## Addendum #3

**Project Name:** Cattle National Bank & Trust - Fallbrook  
6550 Merchant Drive  
**Project No.:** 12054  
**Issued:** May 09, 2013  
**Bid Date:** 2:00 pm, CDT May 14, 2013

EXHIBIT A

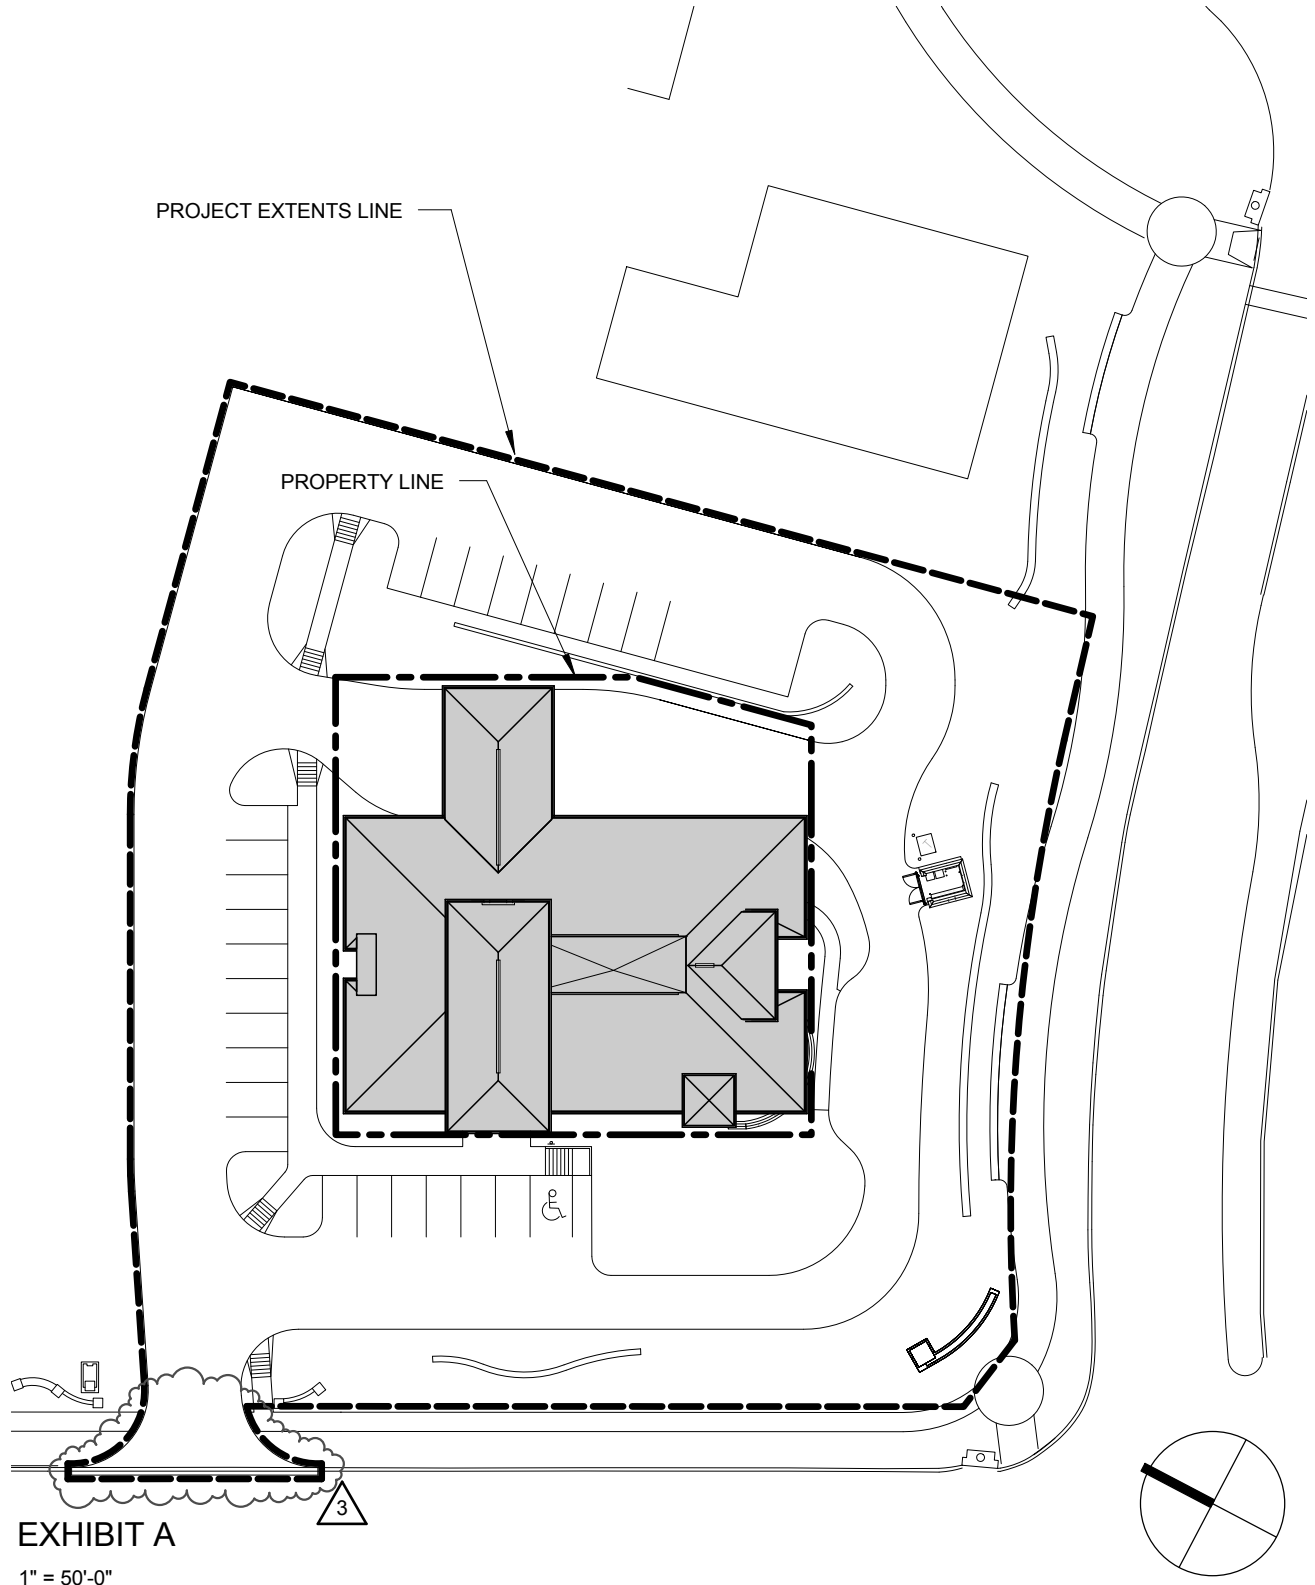
- ADD 1-7.** Exhibit A Project Extents Line has been updated. Refer to attached Exhibit.
- ADD 1-8.** All landscaping from face of building to back of curb and all utilities (storm sewer, water service & electrical services (see E001B)) associated with the building, including extents beyond the property line will be part of Base Proposal One – Building.

Revision to Detail **A4/A110**

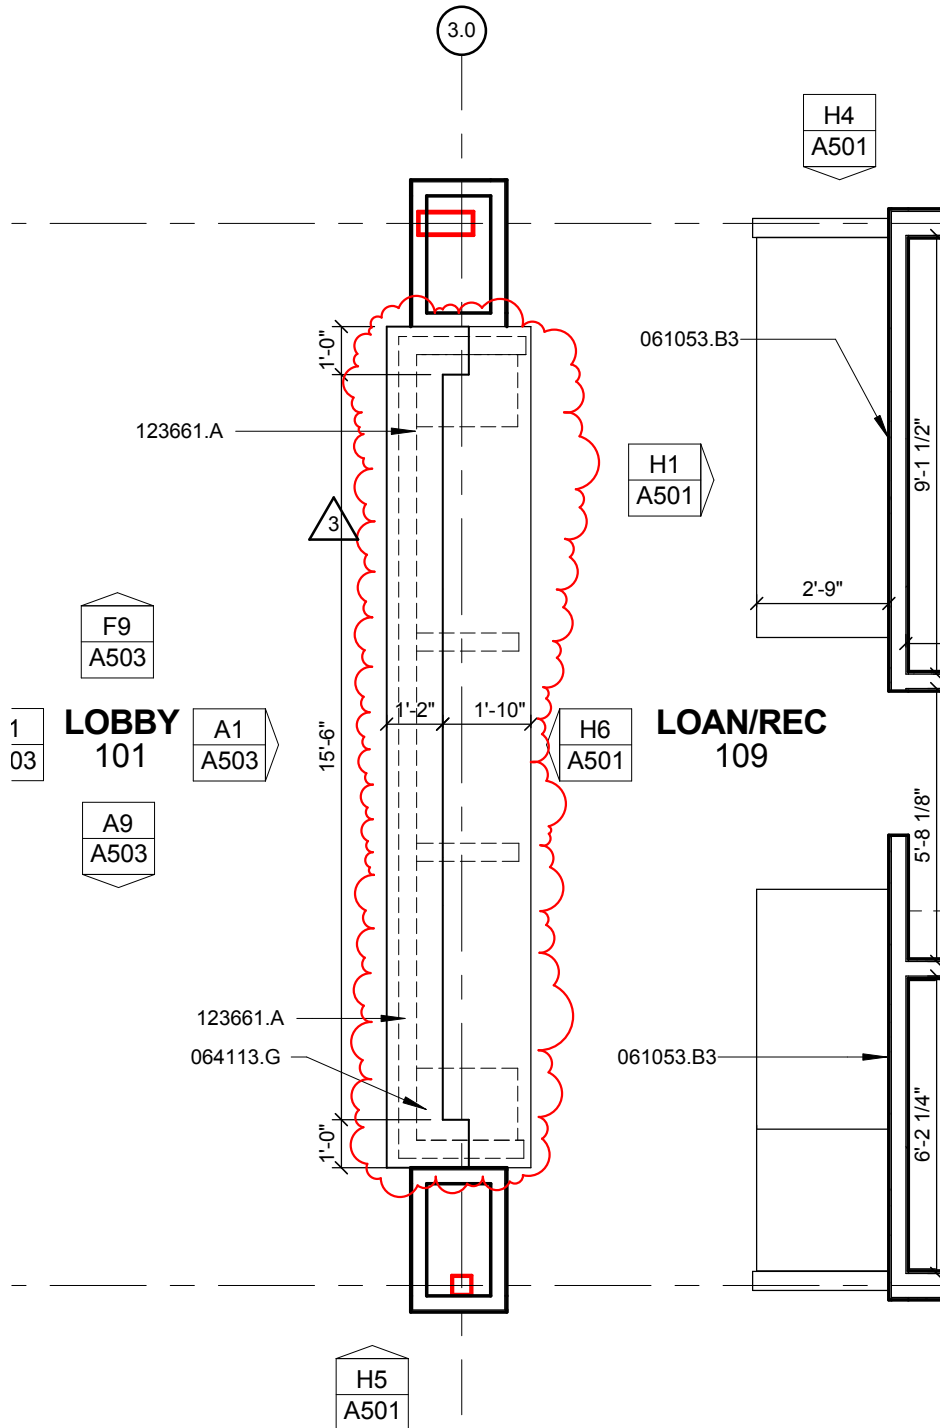
- a. A1/A110: Revised wall at millwork and smartboard. Refer to Attachment A01.
- b. A4/A110: Added dashed lines to show walls under Reception desk. Refer to Attachment A02.
- c. E4/A110: Added note “Tackboard, same as typical office” to Customer Service 105. Refer to Attachment A03.
- d. K1/A110: Removed stud wall inside cavity. Added two partition tags. Added plan detail callout tag. Refer to Attachment A04.
- e. SHEET SPECIFIC NOTES: Added Note 6. Refer to Attachment A03.

Revision to Detail: A1/A302

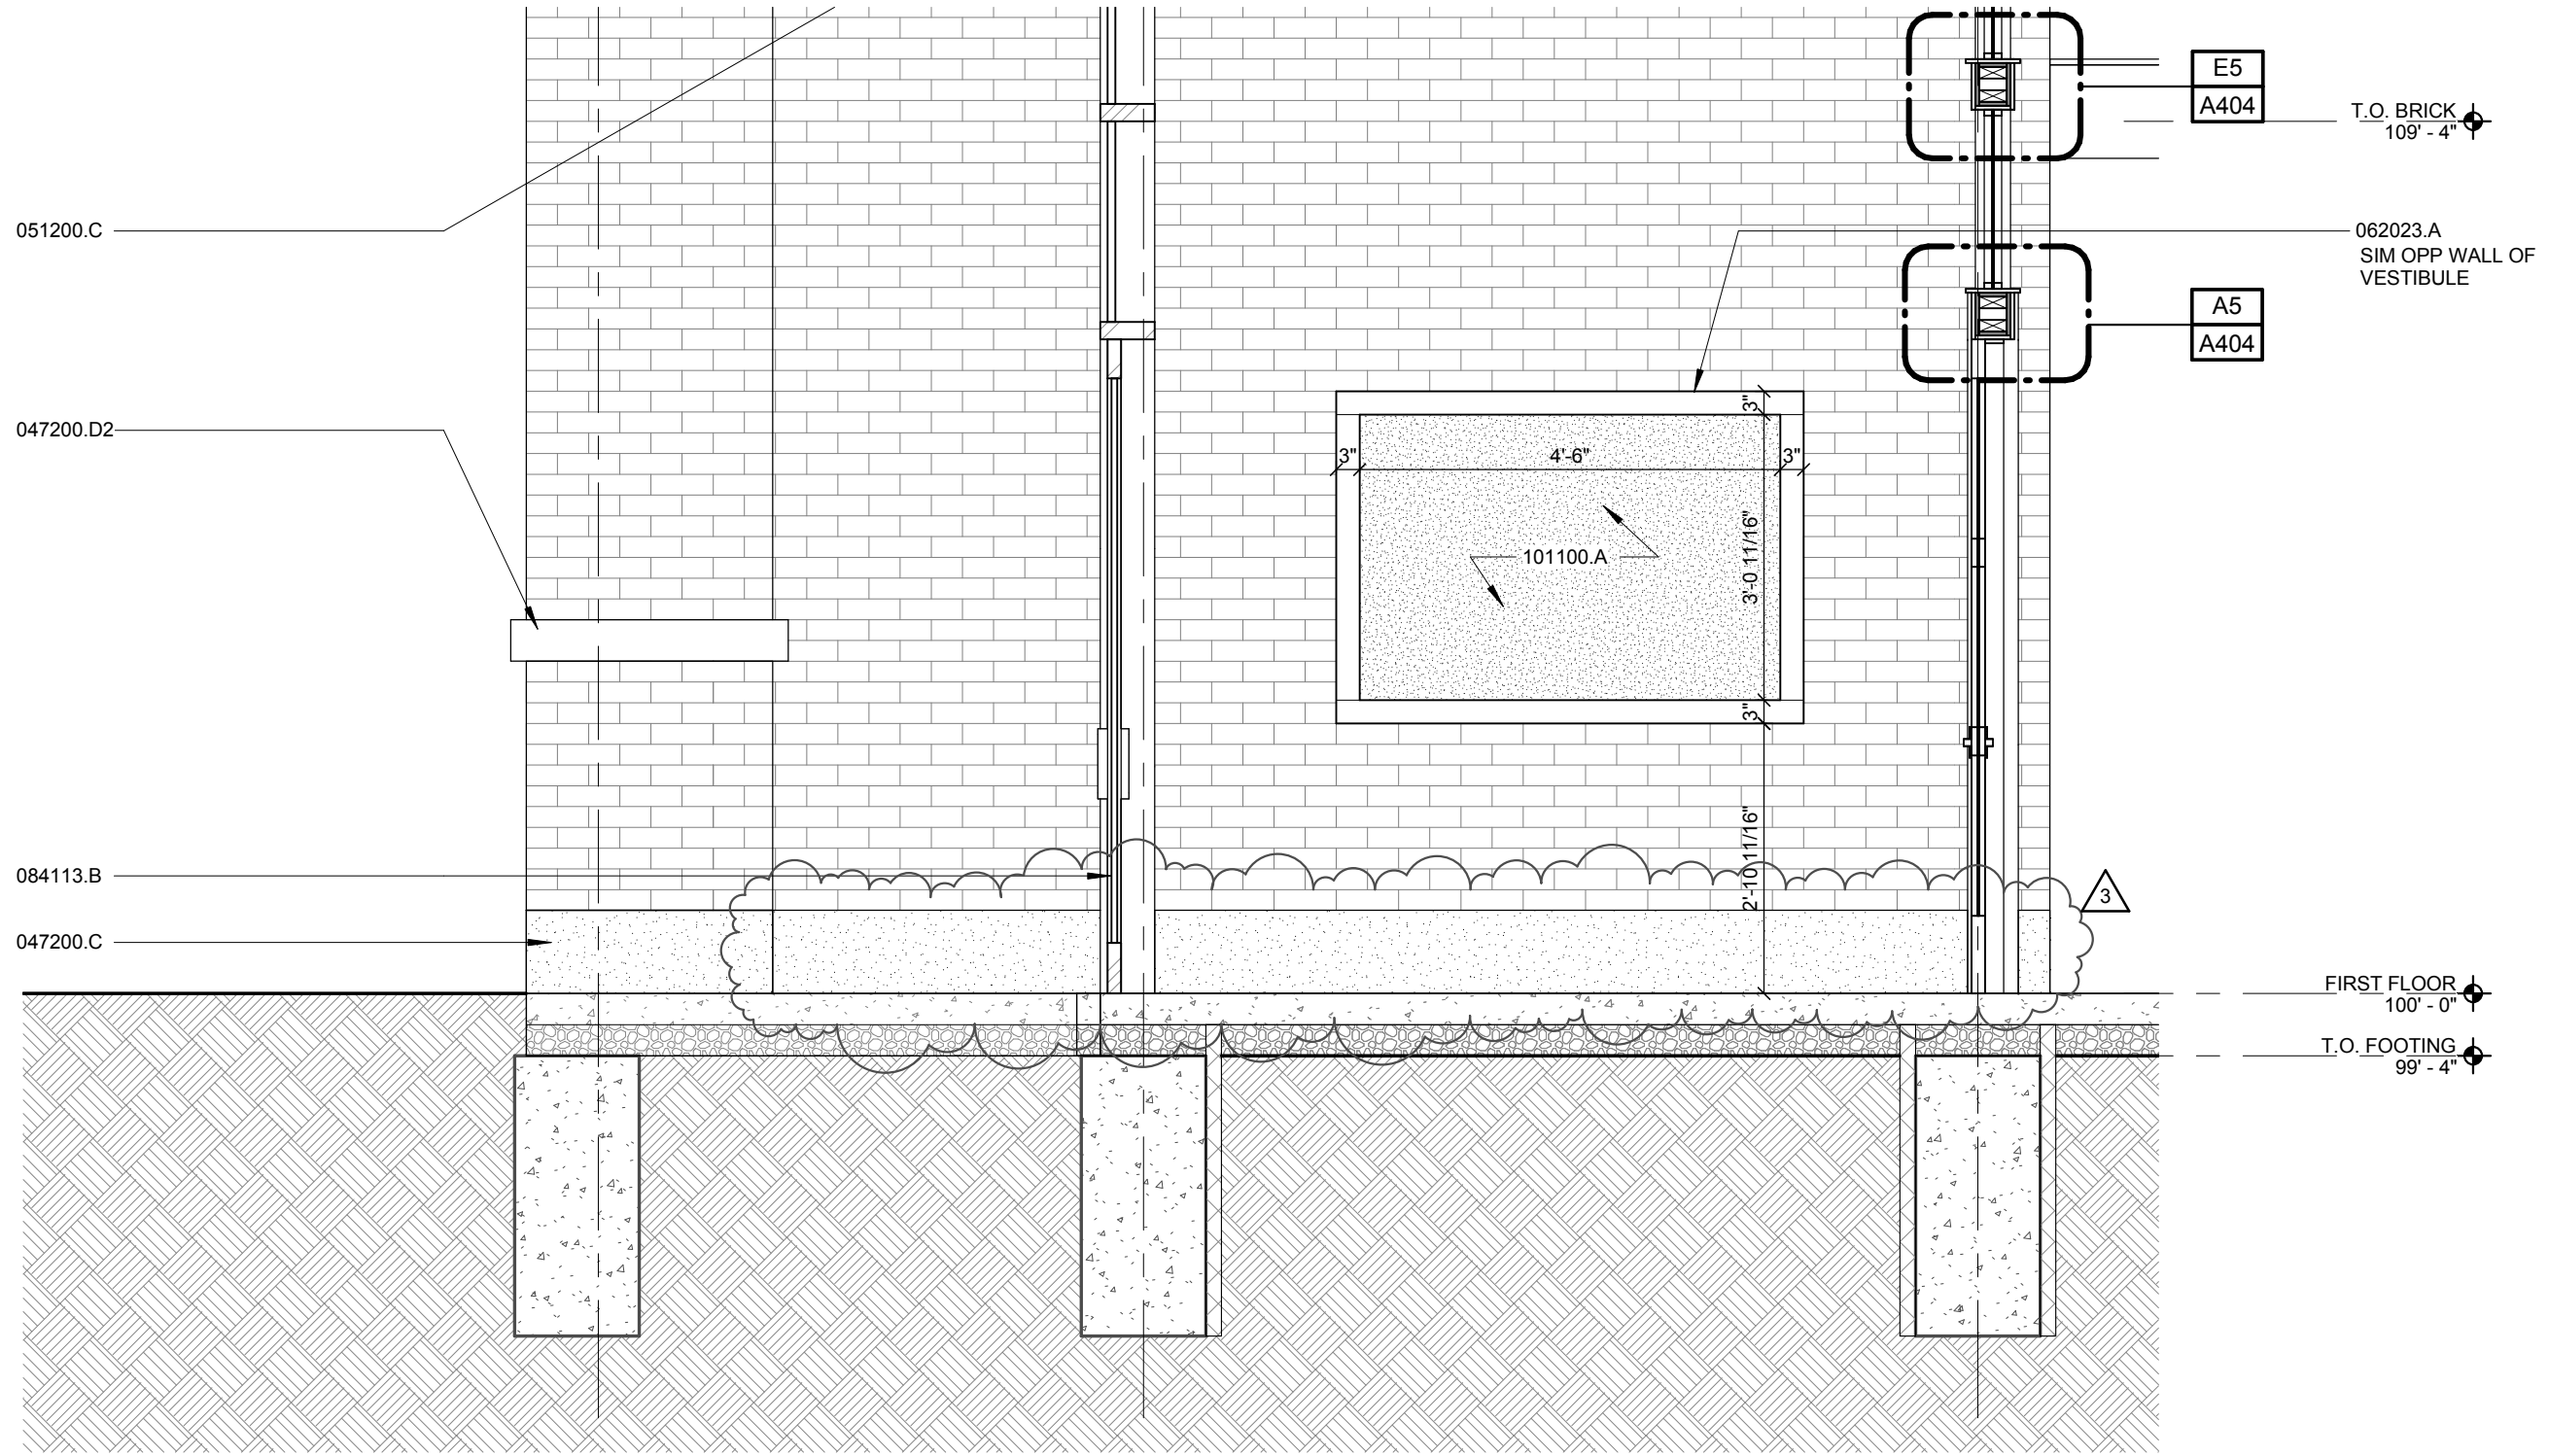
- a. A1/A302: Coordinated drawing with F1/A503. Pre-cast base was missing from drawing. Refer to Attachment A05.
- b. A8/A302: Keynote 083113.B1 “Safety Rail” was modified to read “1 ¼” aluminum pipe safety rail, floor mounted using 2 ¾” x 5 ¼” x ¼” base plate at each corner. Safety rail to include ¼” x 4” toe board.” Drawing was revised to include additional dimensions. Refer to Attachment A06.

Revision to Detail **A1/A401**

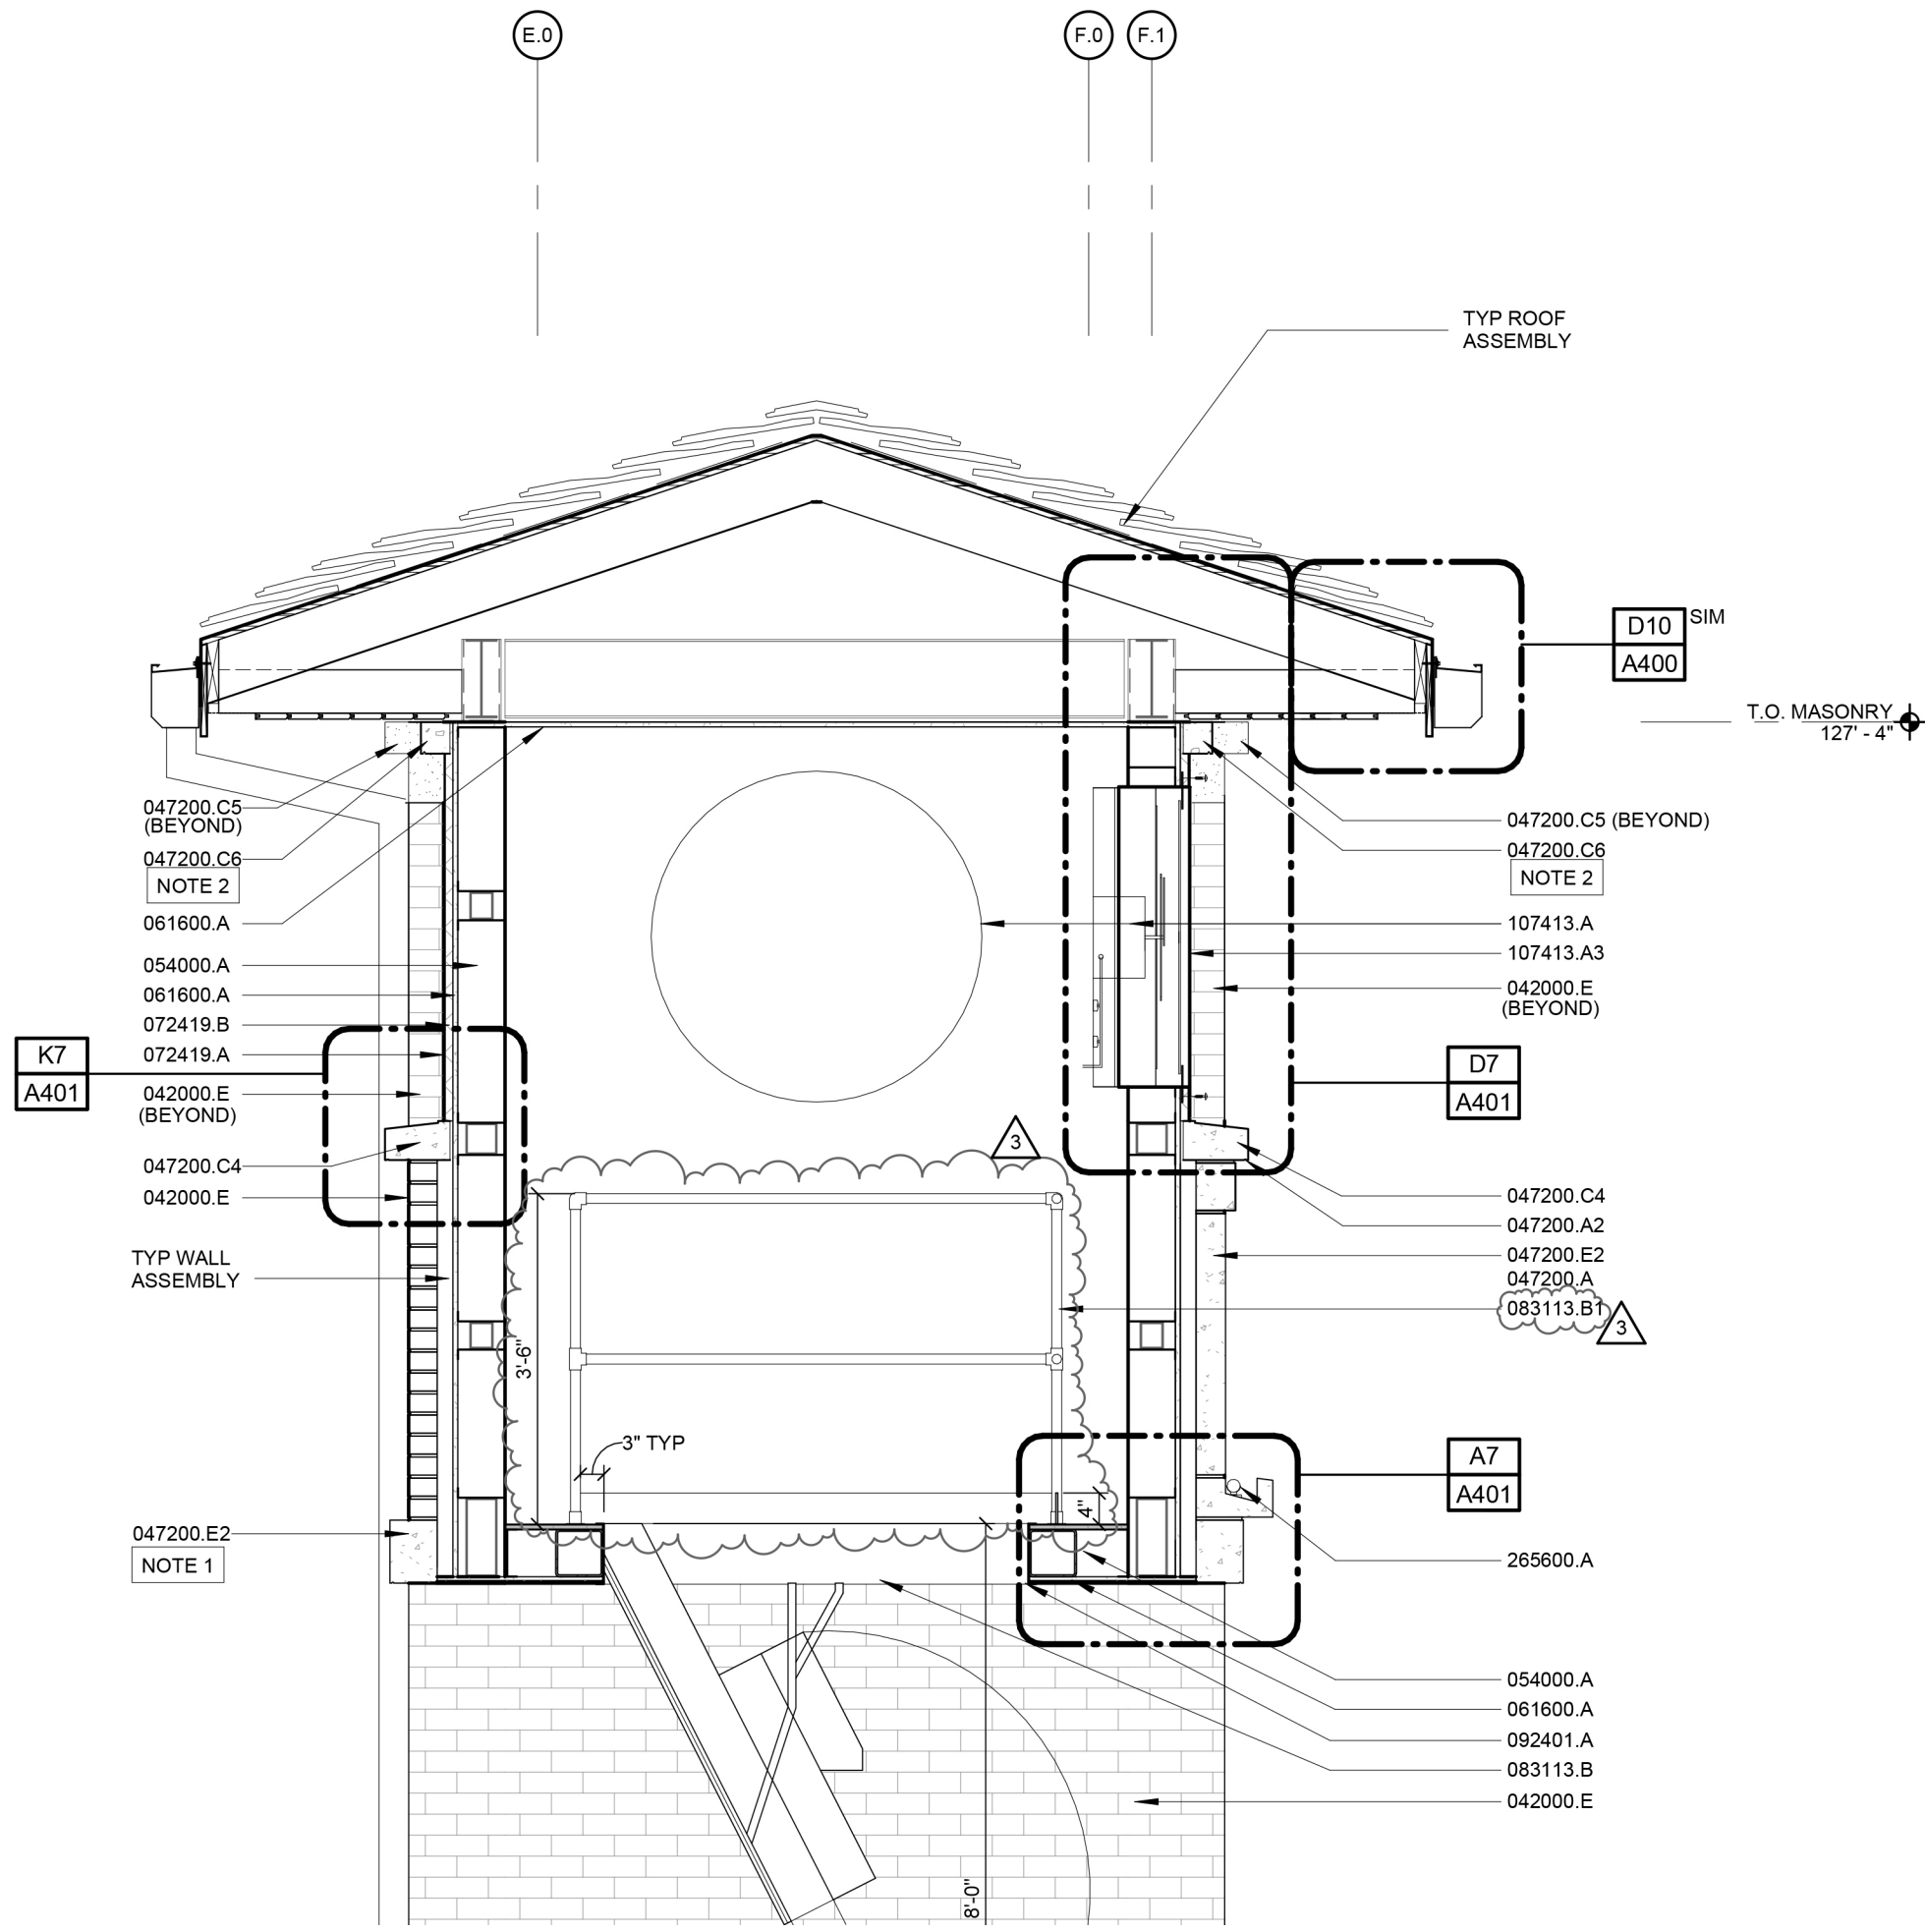
- a. A1/A401: Revised detail. Added keynotes, dimensions and support for interior masonry. Refer to Attachment A07.
- b. E1/A401: Coordinated drawing with structural for brick support. Added keynotes. Refer to Attachment A08.
- c. K4/A401: Revised note to be consistent with the rest of the documents. Teller Window and Teller Drawer are owner provided and installed in coordination with contractor. Refer to Attachment A09.
